**Alcoa of Australia
Limited**

**Attachment 3B: L6465/1989/10
Amendment Supporting
Document**

September 25

Figure 3-2 Updates to Orion Area

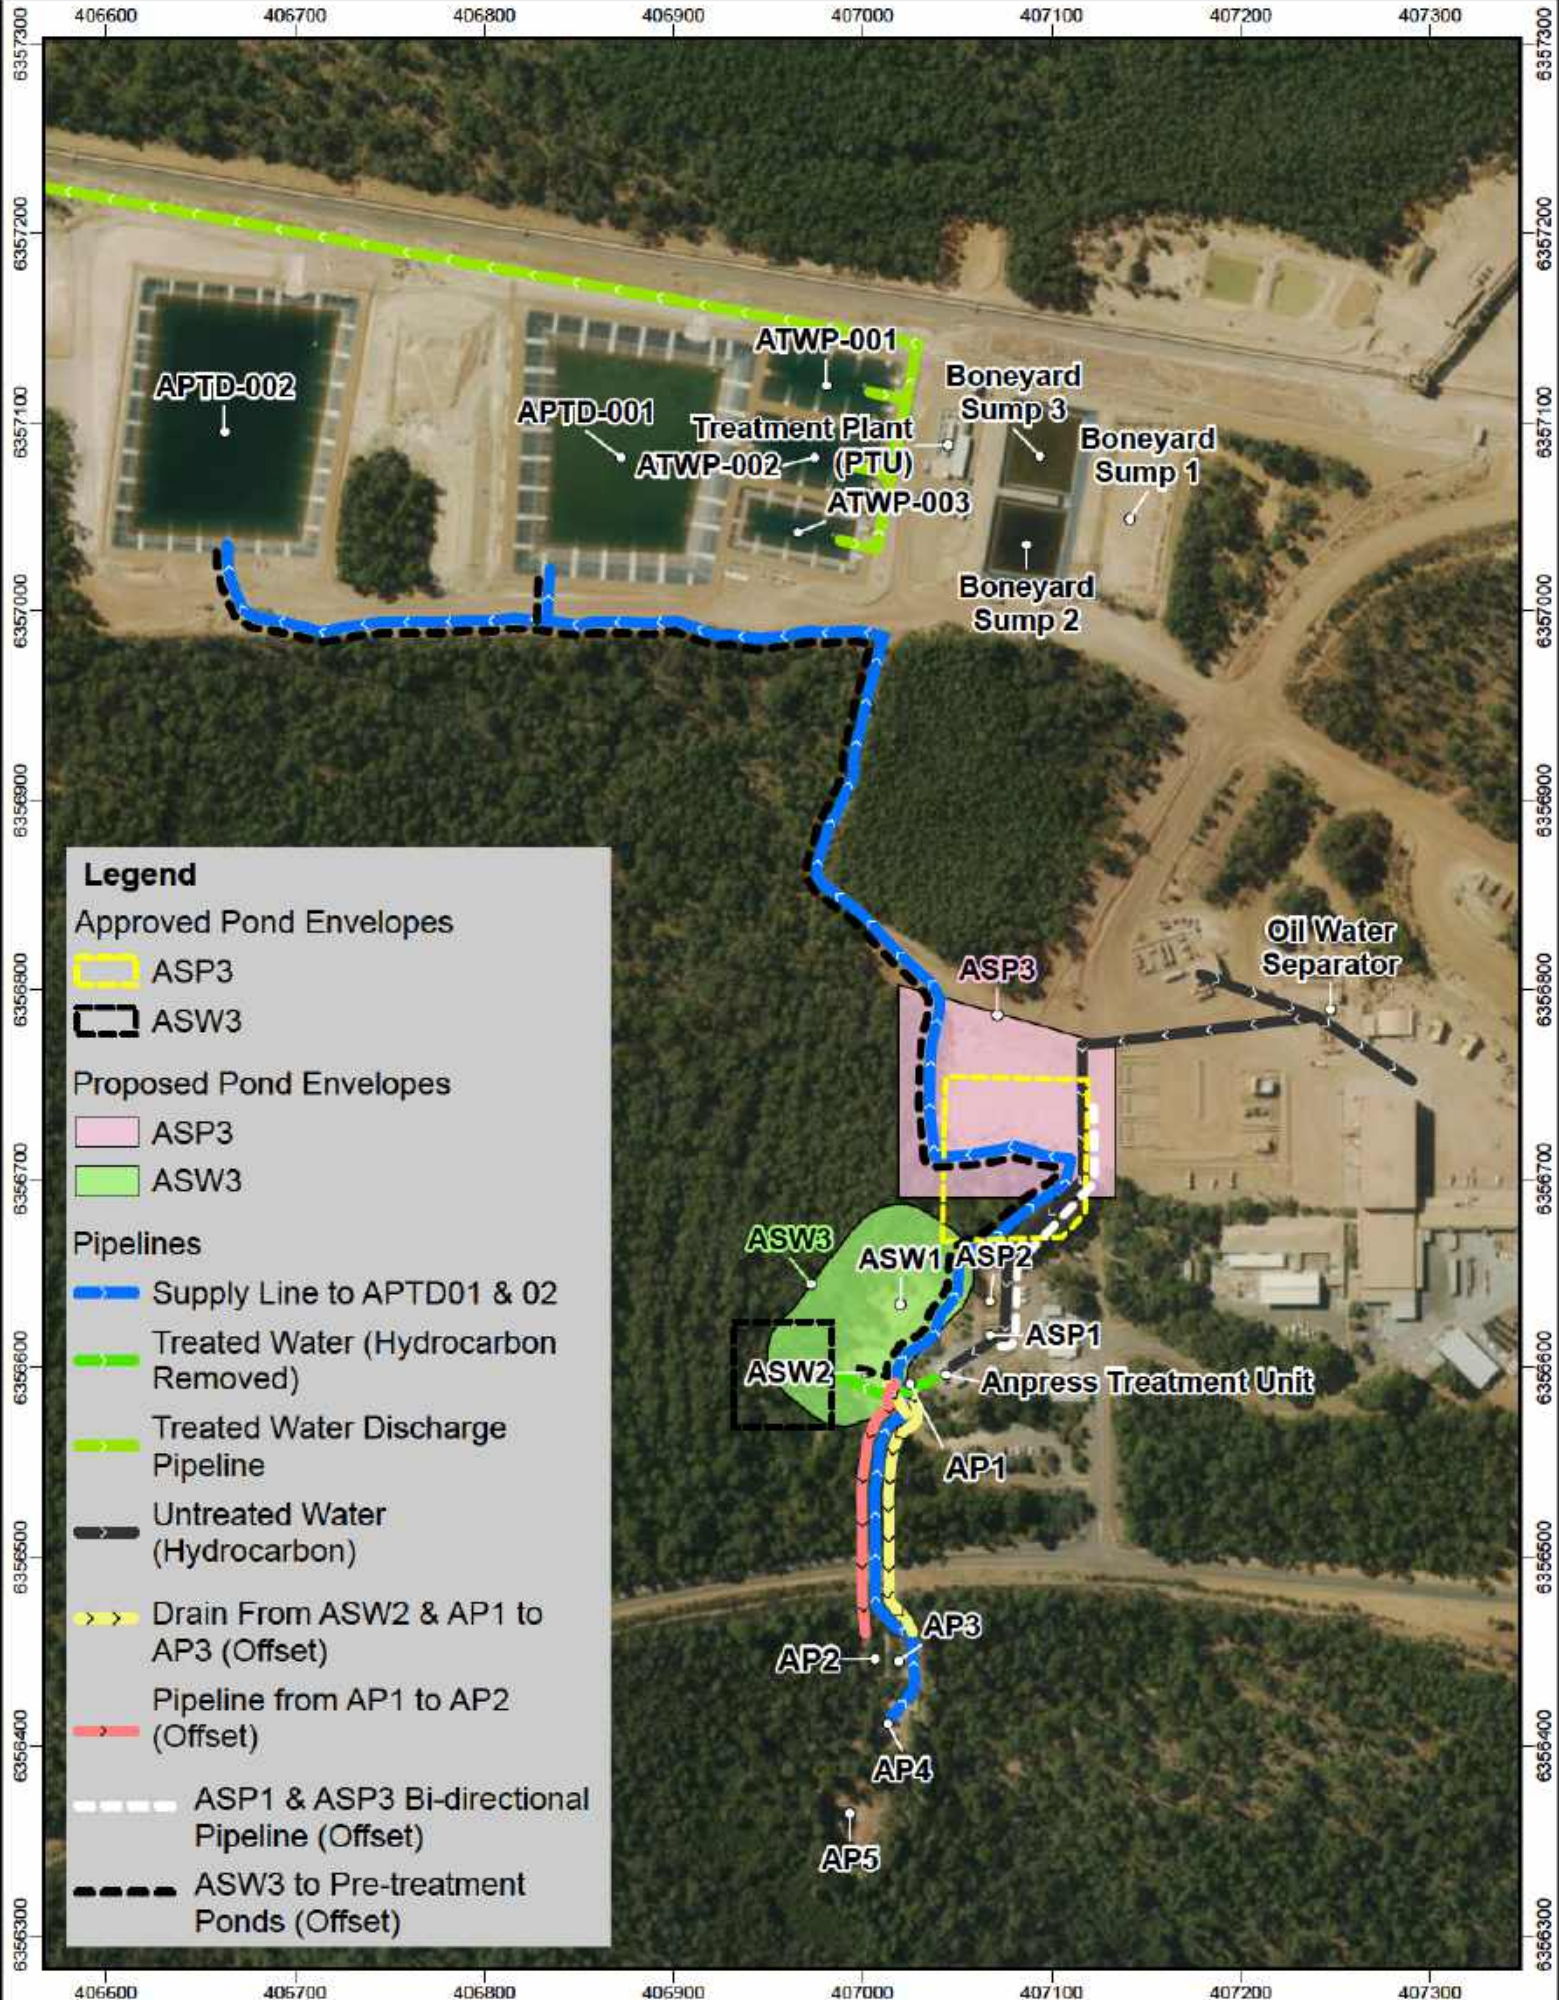
Figure 7 of the existing licence shows an indicative catchment area for Orion Sumps 1 – 3. This catchment can be updated to match the drainage assessment for the site. The proposed change is shown on Figure 3-2 and has been included in the amended figures for the licence (See Section 7).

Figure 4-1 Arundel Ponds

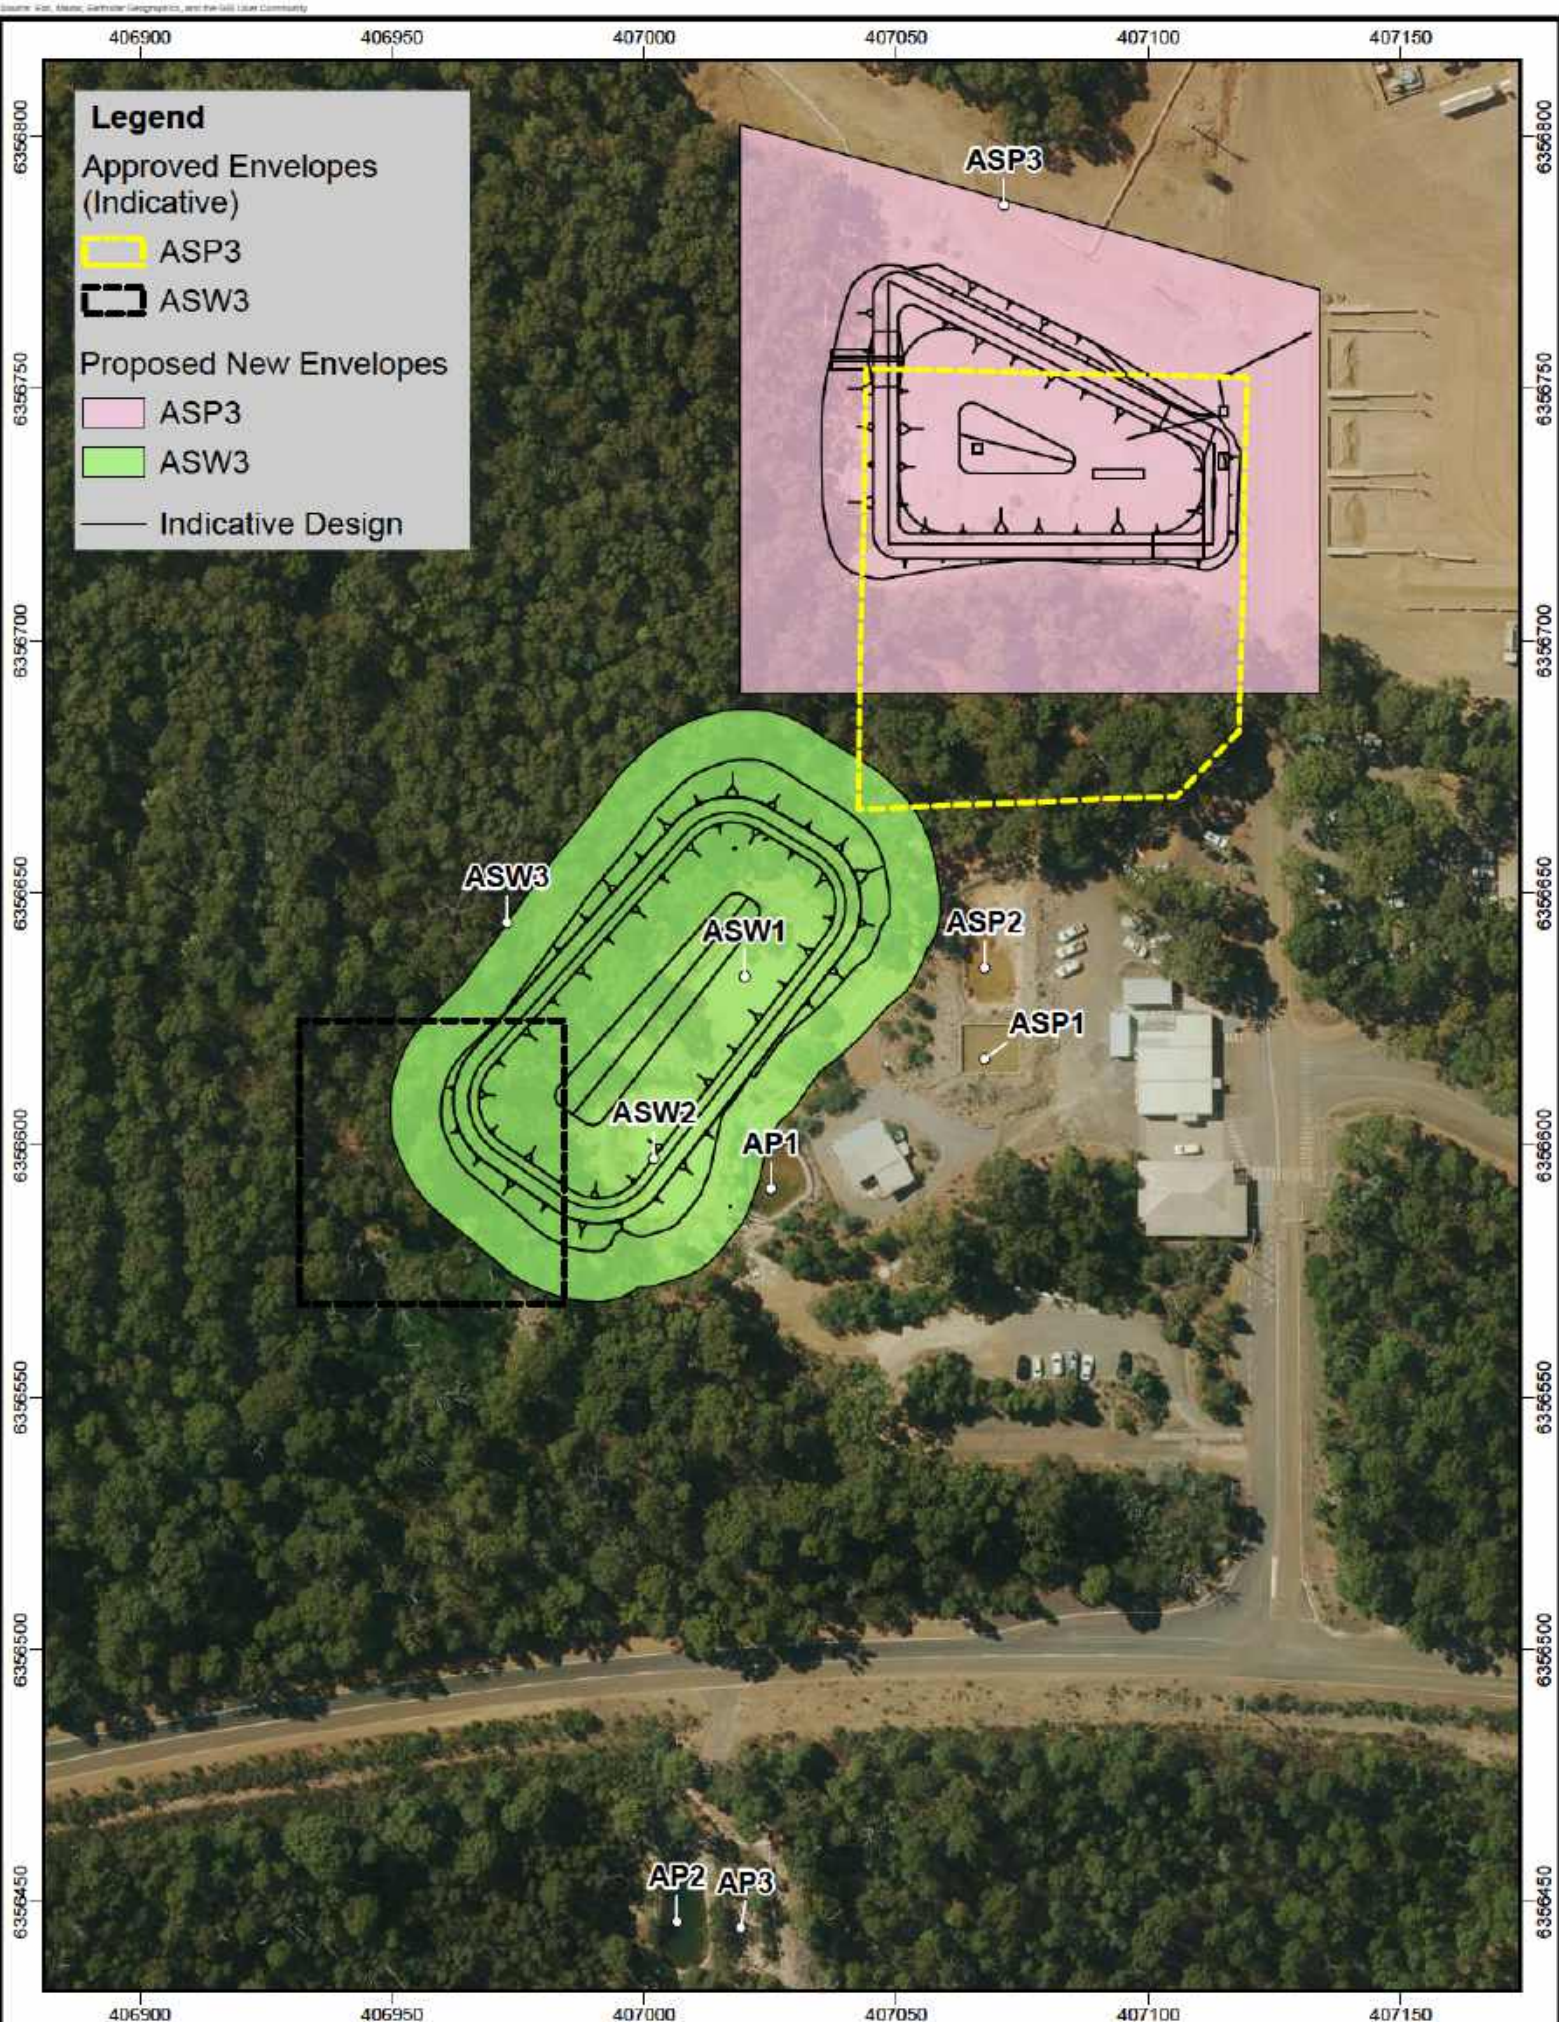
Existing ponds at Arundel and the proposed changes in location of ASW3 are shown in Figure 4-1. The changes are shown at a closer extent in Figure 4-2. These new locations have been included in the proposed revised figures for the licence (Section 7). At the proposed new location, ASW3 will incorporate and replace the existing, unlined ponds ASW1 and ASW2. The increase in capacity compensates for the loss of ASW1 (0.26 ML) and ASW2 (1.1 ML).

A double-skinned HDPE pipeline will be constructed between ASW3 and the PTU Pre-treatment ponds (APTD-001 and APTD-002) in accordance with Condition 1 of the existing licence. The pipeline route is shown on Figure 4-1 and has been included in the amended figures for the licence (See Section 7).

As part of the design change a bi-directional, double skinned HDPE pipeline will be installed inside existing easements between ASP3 and ASP1. The route is shown on Figure 4-1. This pipeline will facilitate two way flow to manage storage capacities in the ponds.

Figure 2 Arundel Infrastructure

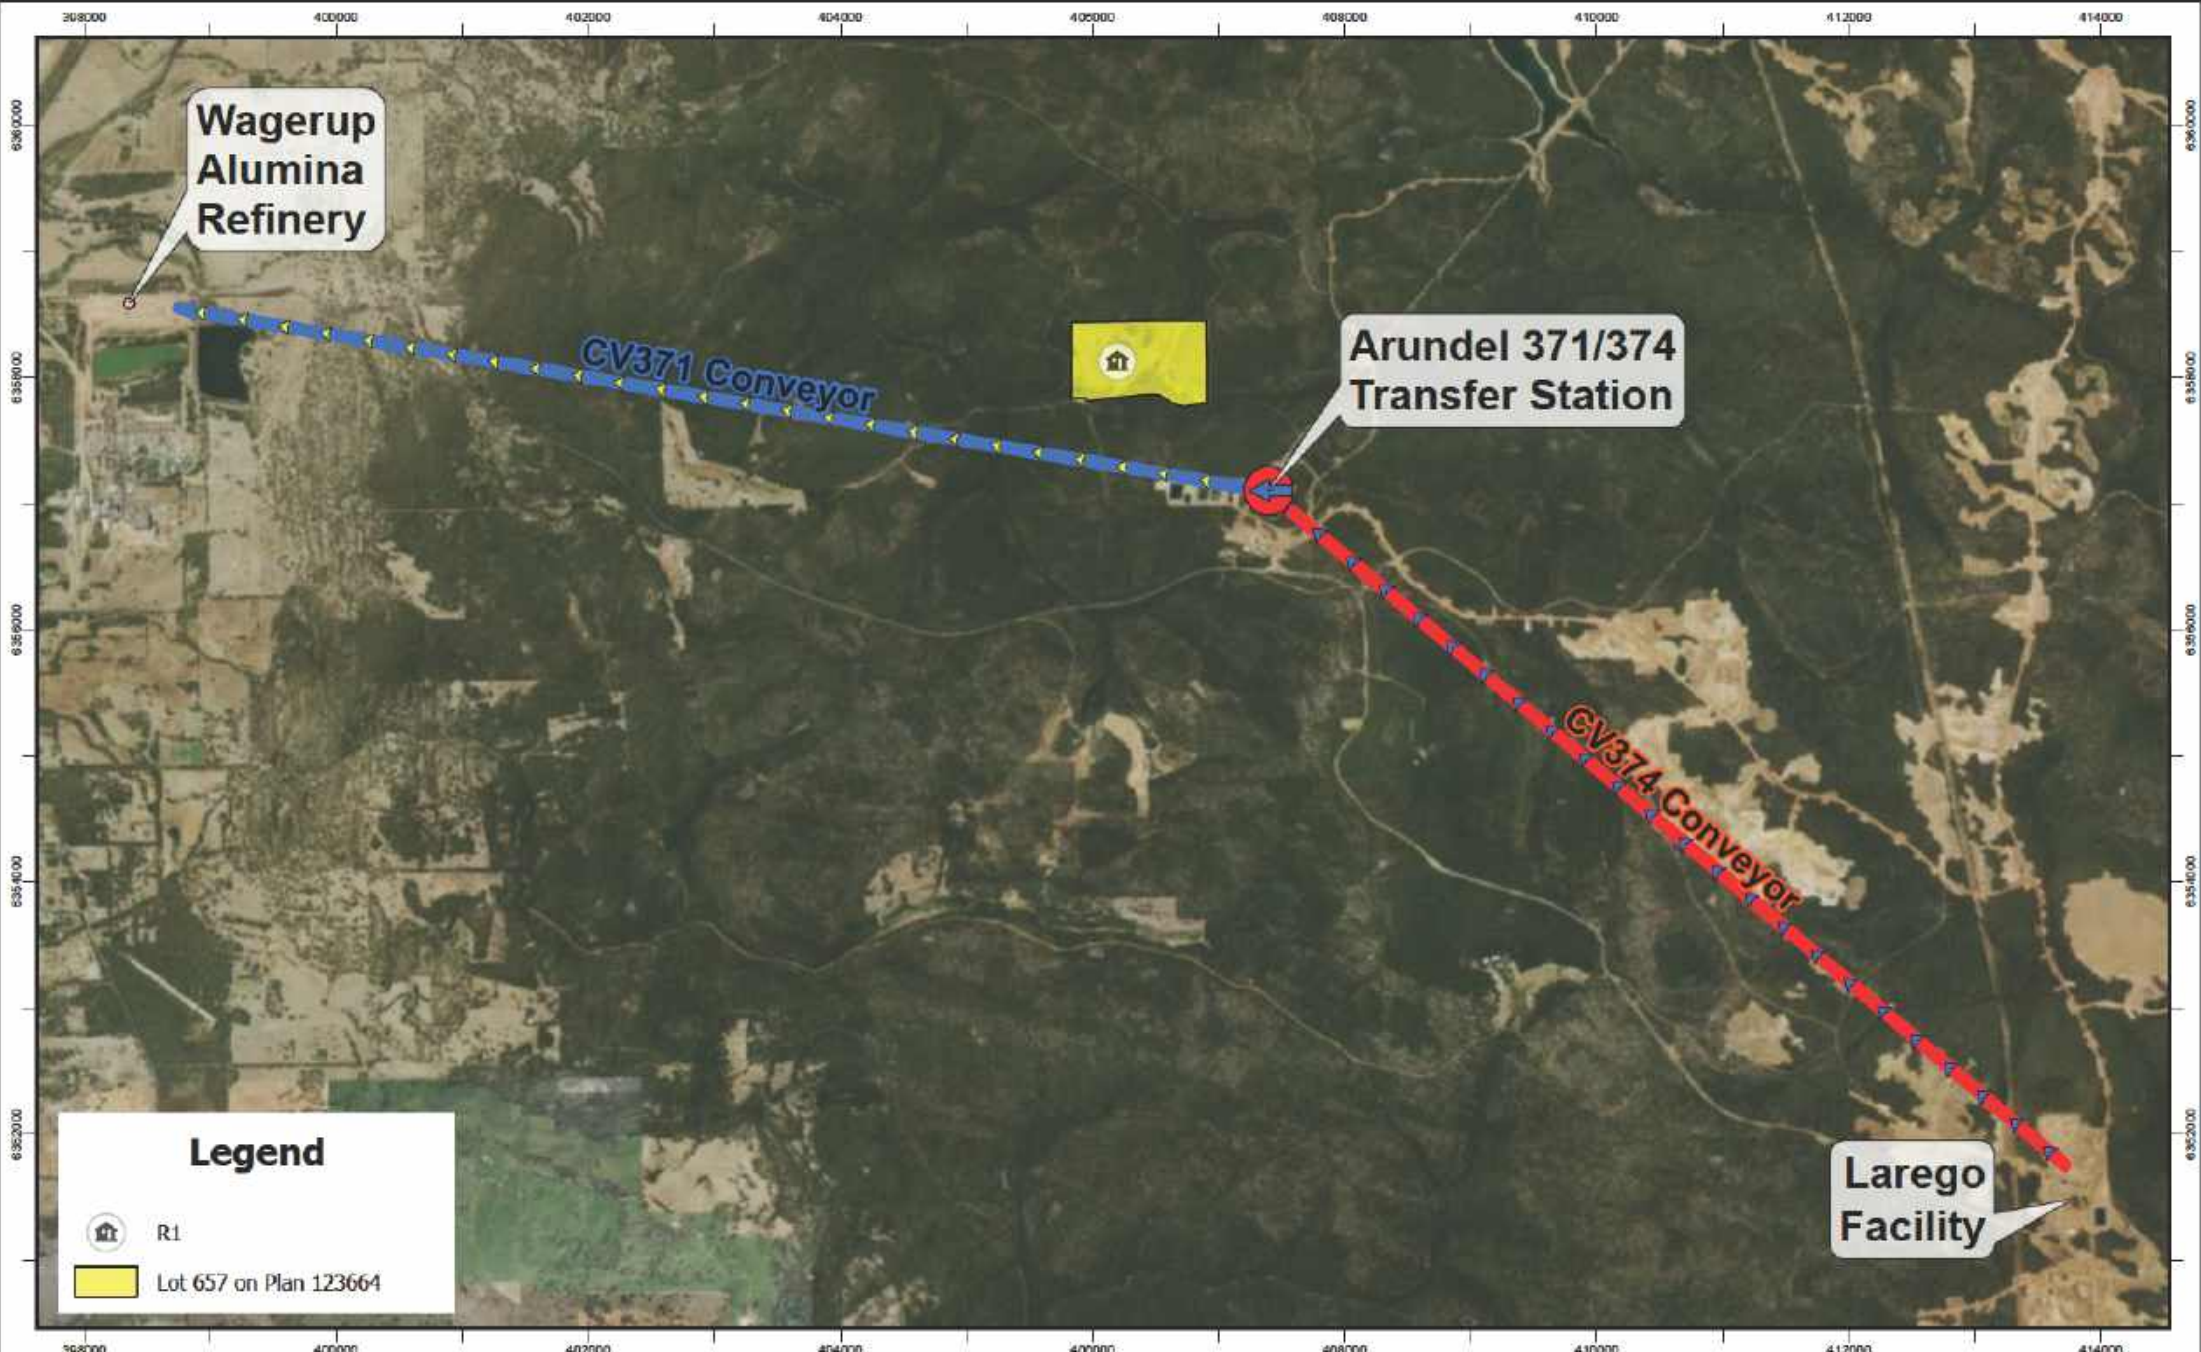
Note that Alcoa has provided a revised set of figures as part of this licence amendment application (See Section 7). The proposed new locations of ASW1 and ASP3 are included in Figure 2 of the proposed new figures.

Infrastructure	Design and construction / installation requirement	Infrastructure location	Timeframe
Arundel Workshop and stormwater collection pond (ASW3)	Arundel Workshop: • 5,000 L underground concrete waste holding pit. Arundel Stormwater collection pond (ASW3): • Storage capacity of 1.5 ML no less than 3 ML; and • Clay liner and HDPE liner to meet maximum permeability of 1×10^{-9} m/s.	Arundel mining area as shown in Figure 2 of Schedule 1 and Arundel infrastructure and equipment as shown in Figure 8 in Schedule 1: Arundel site layout and drainage plan.	N/A
Anpress Pre-treatment sump (ASP3)	• Storage Capacity up to 1.5 ML • Lined to meet maximum permeability of 1×10^{-9} m/s • Minimum design freeboard 1 m (sufficient to cater for a 1:100 year AEP 72 hr rainfall event) • Double-skinned, HDPE pipeline between ASP3 and ASP1 to be constructed inside existing easements.	Arundel infrastructure and equipment as shown in Figure 8 Figure 2 of Schedule 1: Arundel site layout and drainage plan
